ICC 2021 Code Changes

This document created by the Florida Department of Business and Professional Regulation -
850-487-1824

TAC: Special Occupancy

FIGURE 3114.8.5.3(1)
BRACING UNIT DISTRIBUTION—MAXIMUM LINEAR LENGTH

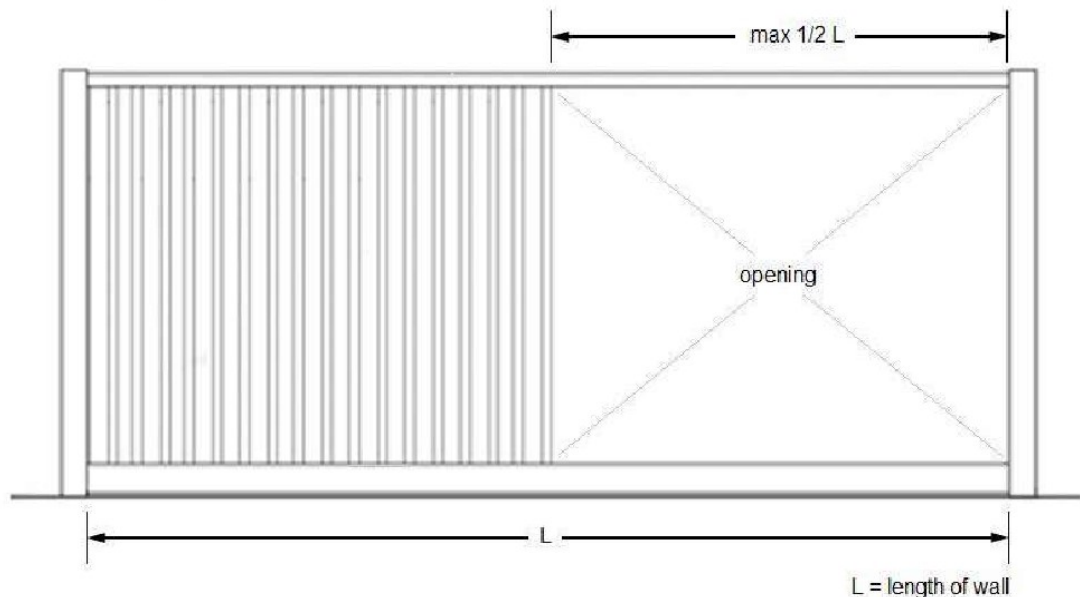
1. The total linear length of all openings in any individual side walls or end walls shall be limited to not more than 50% of the length of that side walls or end walls, as shown in Figure 3114.8.5.3(1).

FIGURE 3114.8.5.3(2)
BRACING UNIT DISTRIBUTION -- MINIMUM LINEAR LENGTH

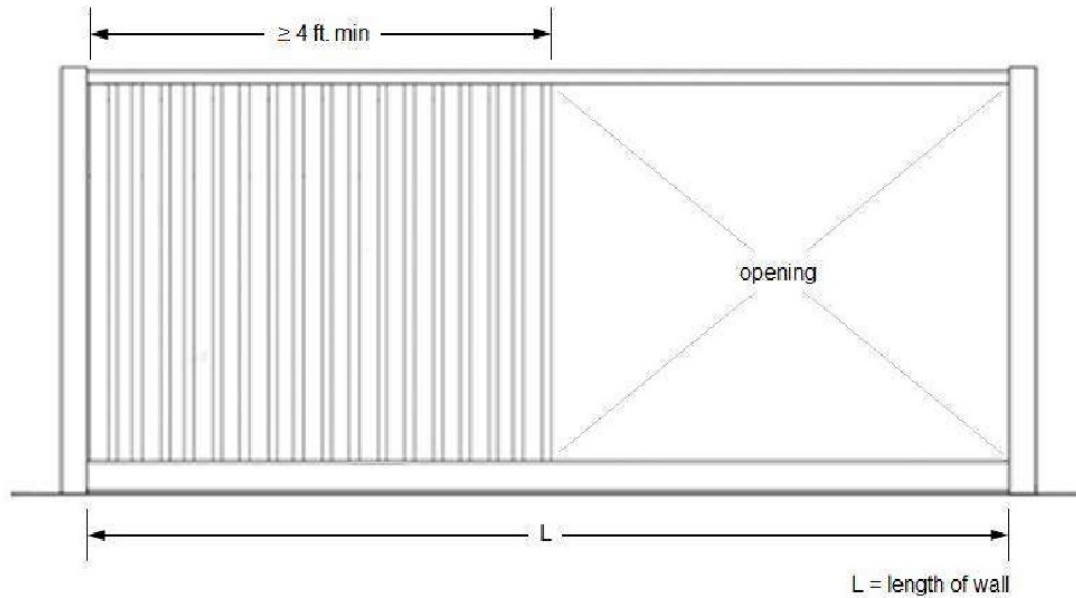
2. Any full height wall length, or portion thereof, less than 4 feet (305 mm) long shall not be considered as a portion of the lateral force-resisting system, as shown in Figure 3114.8.5.3(2).

FIGURE 3114.8.5.3(3)
BRACING UNIT DISTRIBUTION -- BOUNDARY ELEMENTS

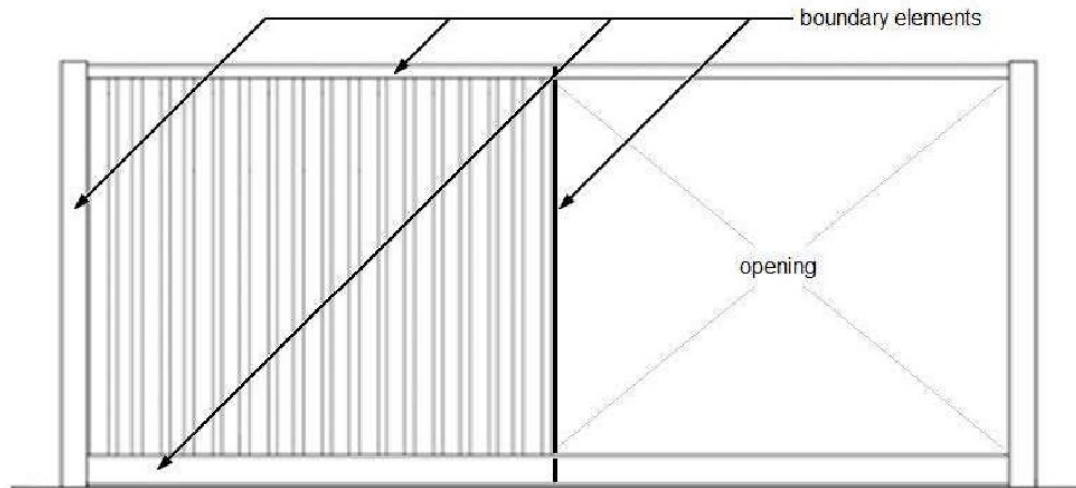
3. All side walls or end walls used as part of the lateral force-resisting system shall have an existing or new boundary element on all sides to form a continuous load path, or paths, with adequate strength and stiffness to transfer all forces from the point of application to the final point of resistance, as shown in Figure 3114.8.5.3(3).

FIGURE 3114.8.5.3(4)
BRACING UNIT DISTRIBUTION -- PENETRATION LIMITATIONS

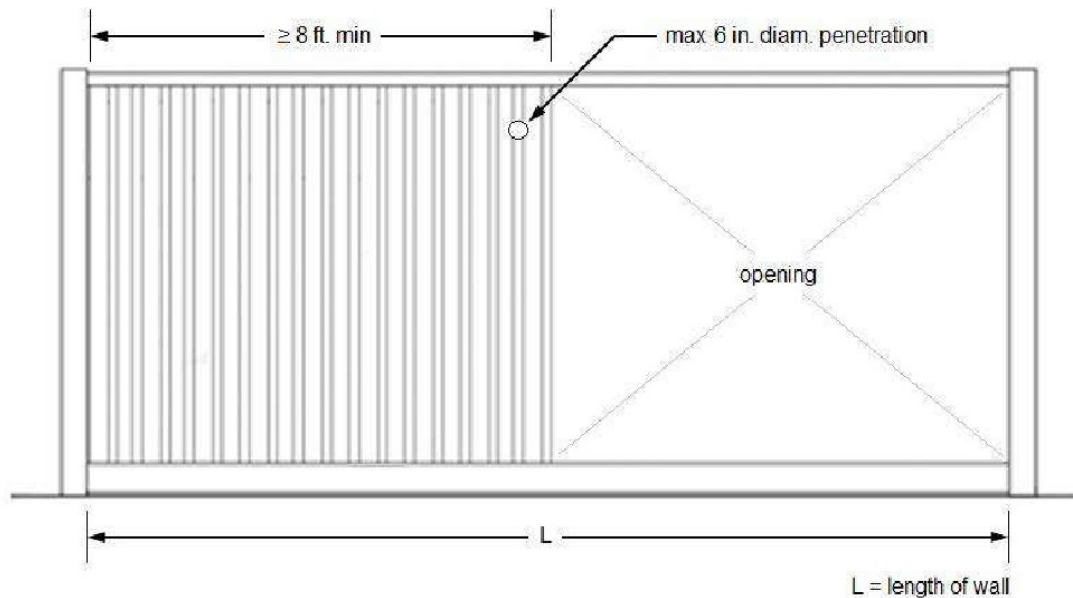
- 4.2. The cross section and material grade of any new steel element shall be equal to or greater than the steel element removed.
5. A maximum of one penetration not greater than a 6-inch (152 mm) diameter hole for conduits, pipes, tubes or vents, or not greater than 16 square inches (10,322 sq mm) for electrical boxes, is permitted for each individual 8 foot length (2,438 mm) lateral force resisting wall. Penetrations located in walls that are not part of the wall lateral force resisting system shall not be limited in size or quantity. Existing intermodal shipping container vents shall not be considered a penetration, as shown in Figure 3114.8.5.3(4).

5. A maximum of one penetration not greater than a 6-inch (152 mm) diameter hole for conduits, pipes, tubes or vents, or not greater than 16 square inches (10,322 sq mm) for electrical boxes, is permitted for each individual 8 foot length (2,438 mm) lateral force resisting wall. Penetrations located in walls that are not part of the wall lateral force resisting system shall not be limited in size or quantity. Existing intermodal shipping container vents shall not be considered a penetration, as shown in Figure 3114.8.5.3(4).

FIGURE 3114.8.5.3(1)
BRACING UNIT DISTRIBUTION—MAXIMUM LINEAR LENGTH

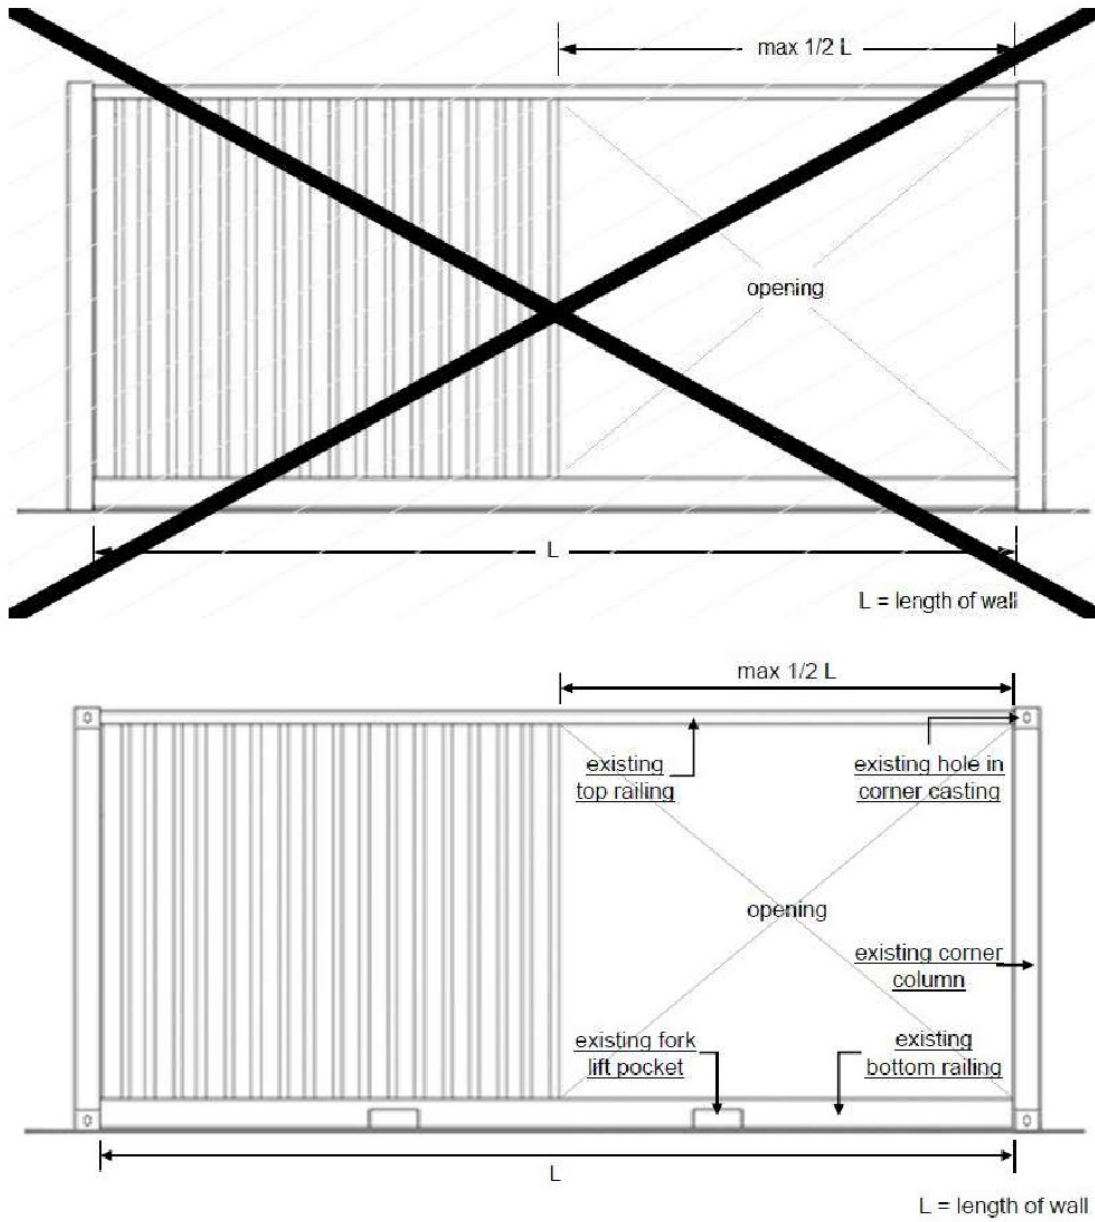
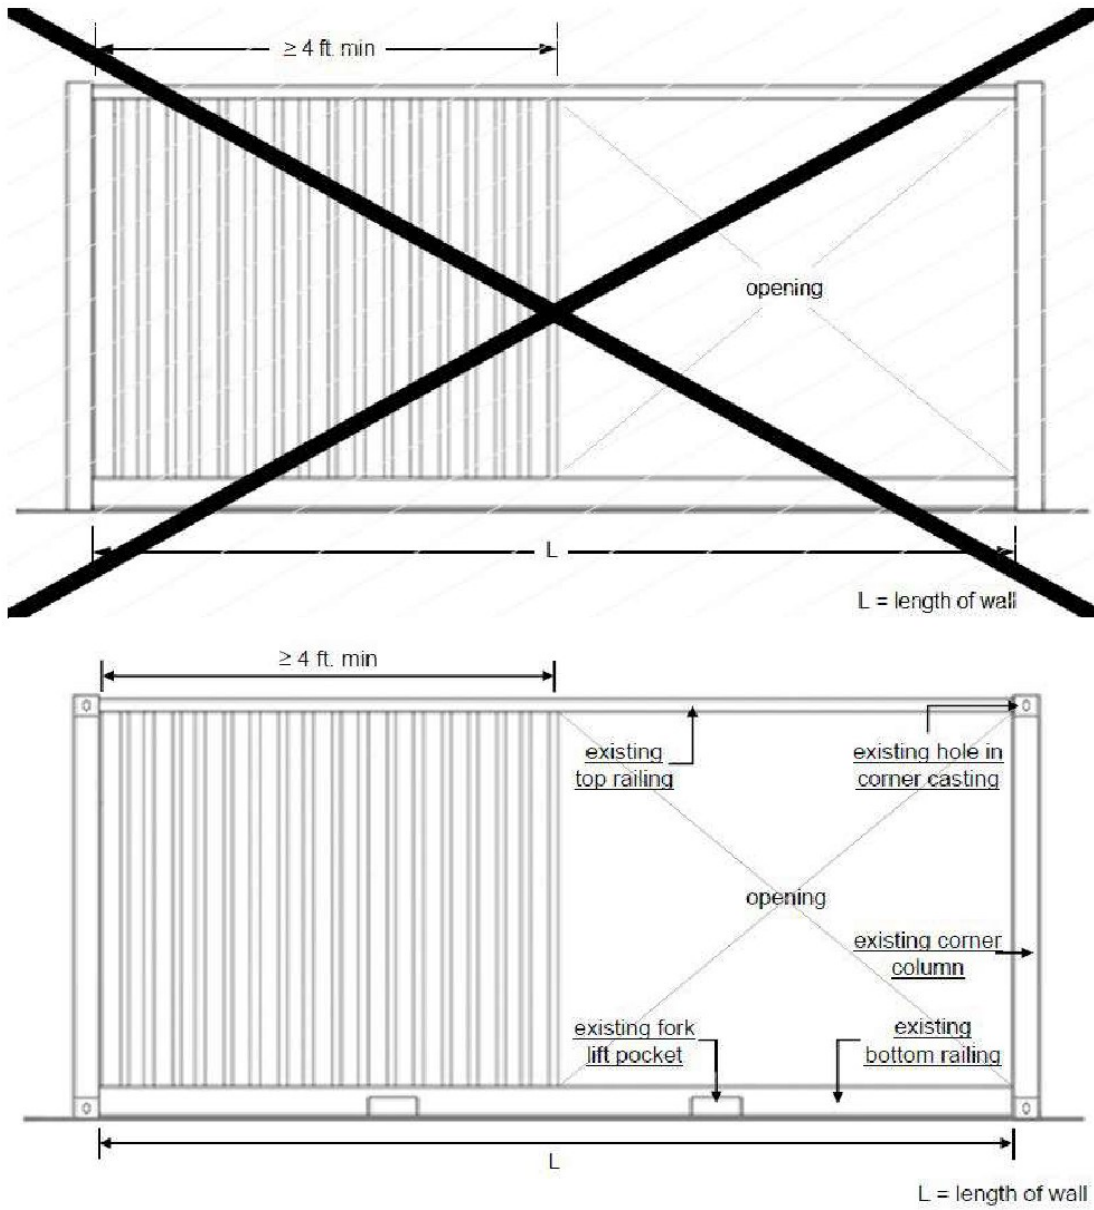
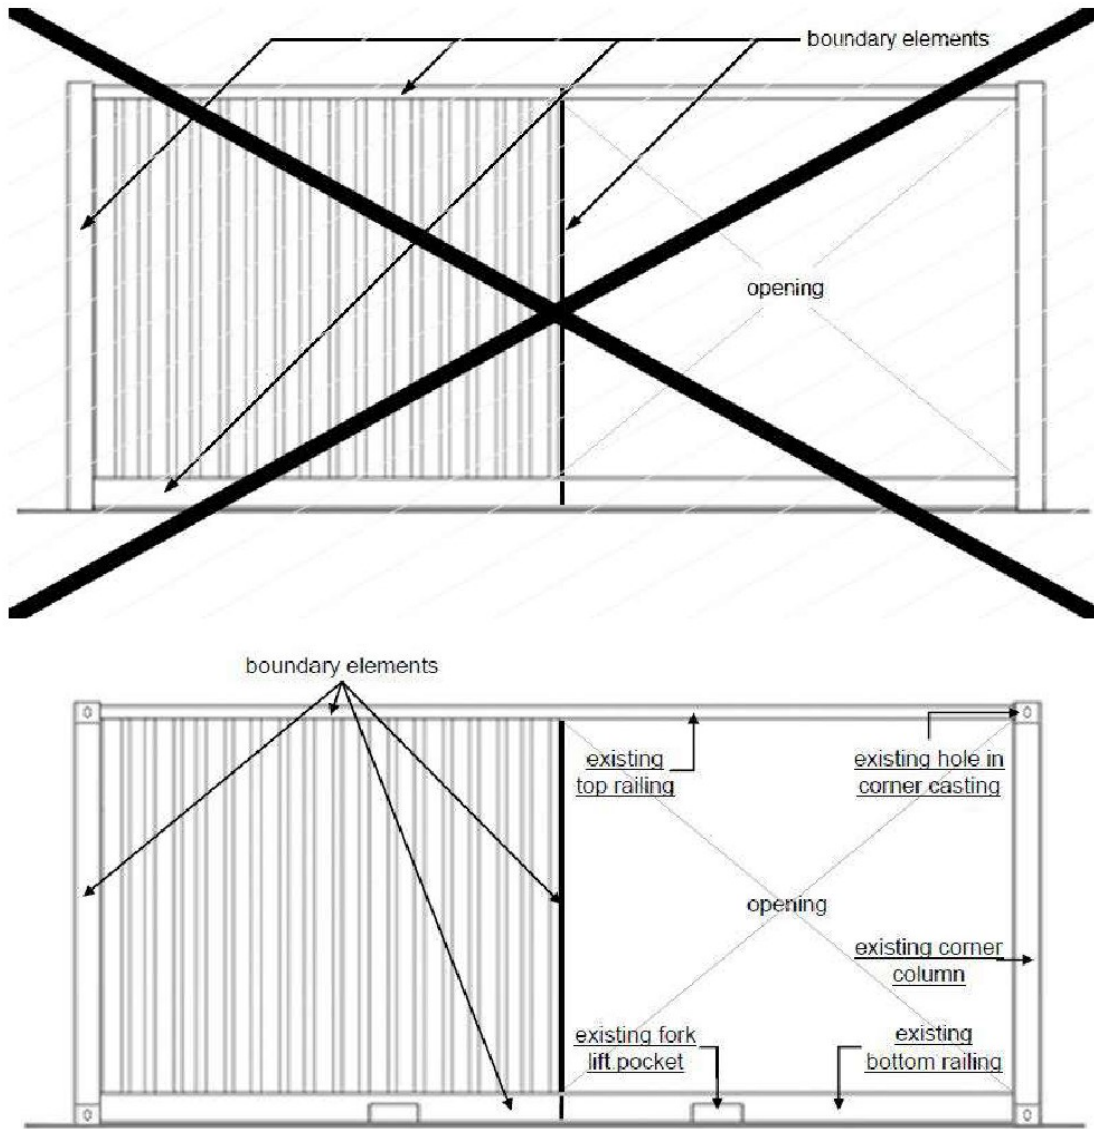
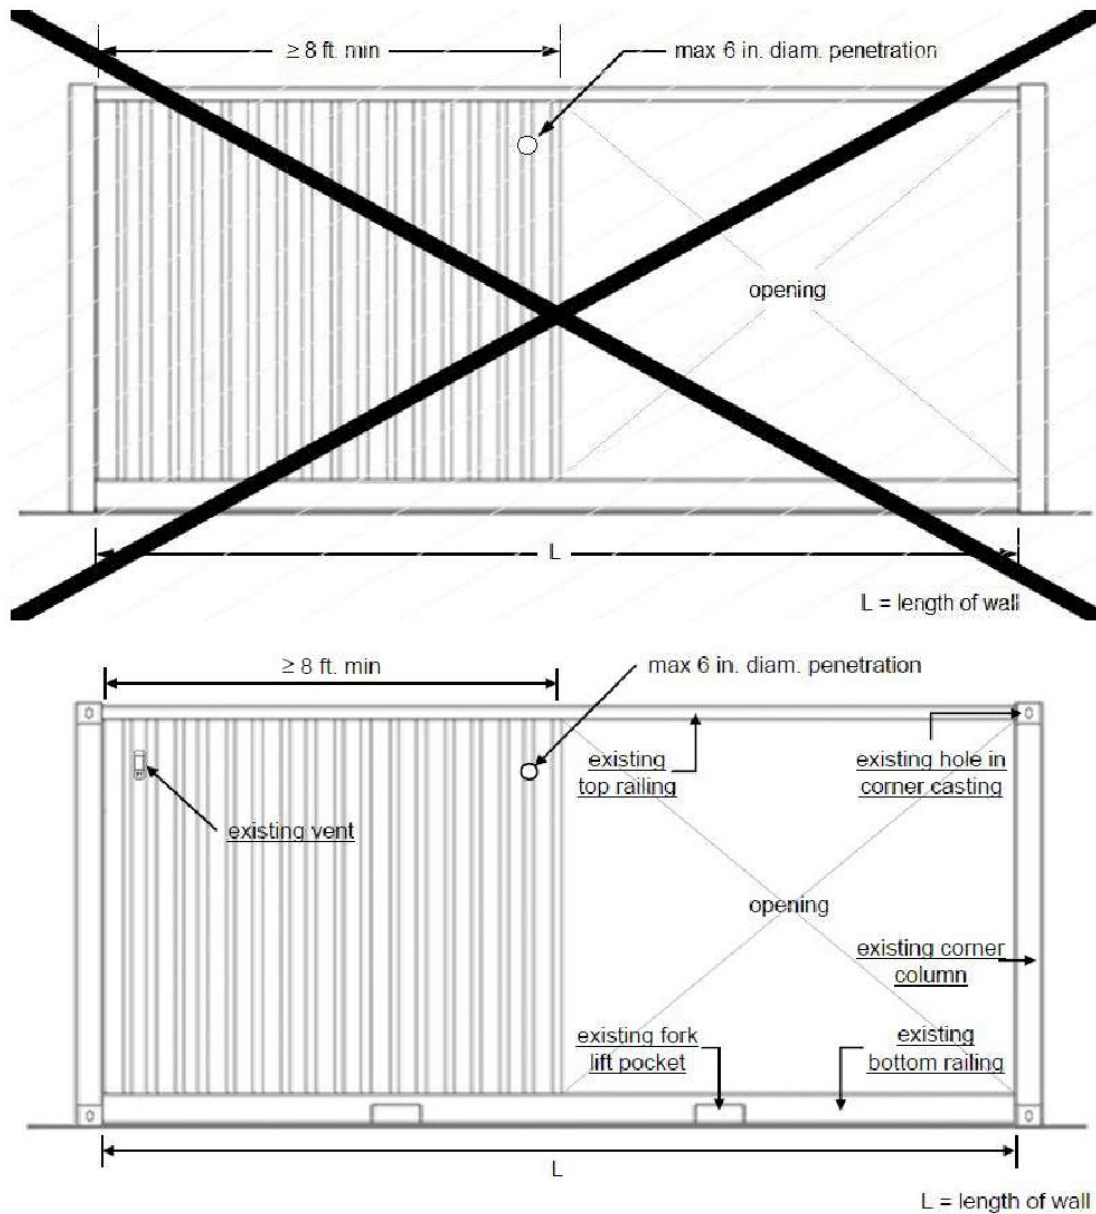
Figures 3114.8.5.3 (1) through (4) – It was brought to our attention that it may be beneficial to identify parts of the intermodal shipping container more clearly rather than use a simple line drawing figure. This is for the benefit of the user to more readily recognize existing conditions versus the permissible cut-aways as allowed by Section 3114.8.5.3. In response we are proposing to add identifying text (the rails, lift slots, and holes) to illustrate those existing elements that are part of the manufacture of intermodal shipping containers.
